# SERVICE LETTER

NUMBER: DK3003

SUBJECT: DATA RELIABILITY

PRODUCT EFFECTED: All D3000 series disks shipped prior to March 1, 1973. (Logic PCBA)

FIGURE 1.A

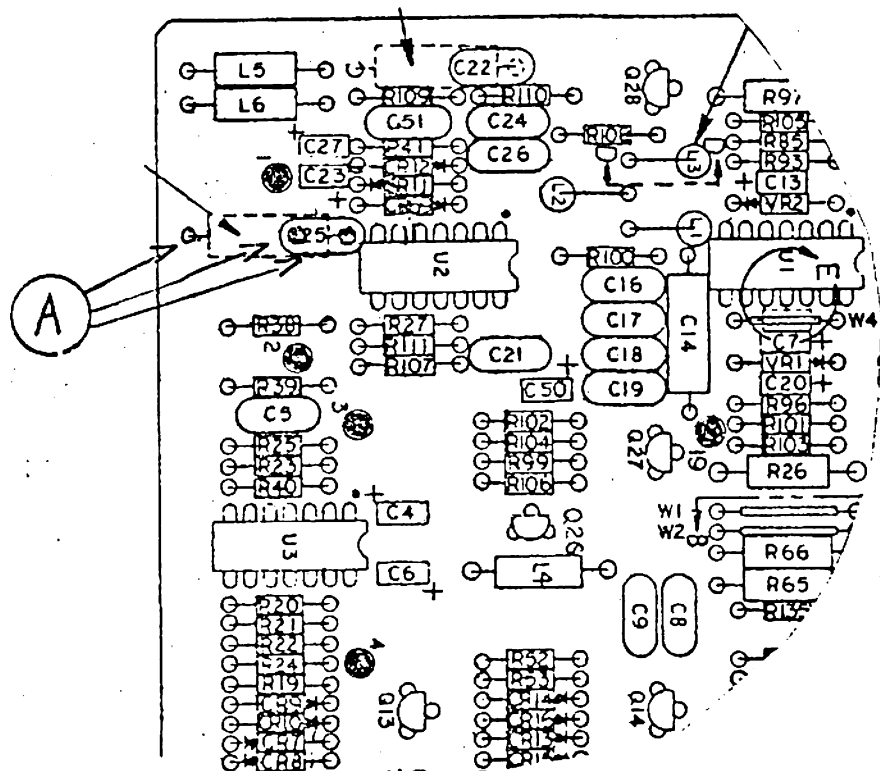
INFORMATION: A problem of data reliability at reduced (1/3) gain on a D3000 disk has been uncovered by the Q.A. Department.

C-25 has been either misinstalled in wrong locator holes (see Fig. 1.A) and/or has been given the wrong value (47PF as opposed to 470 PF) on the Logic PCBA.

ACTION: Although Q.A. generally believes that no units have been shipped from Pertec with these problems, a possibility exists that one or two units may be in the field with either of these problems. If data errors occur only at 1/3 gain, it would be worthwhile checking to see that C-25 is installed properly and is the proper value.
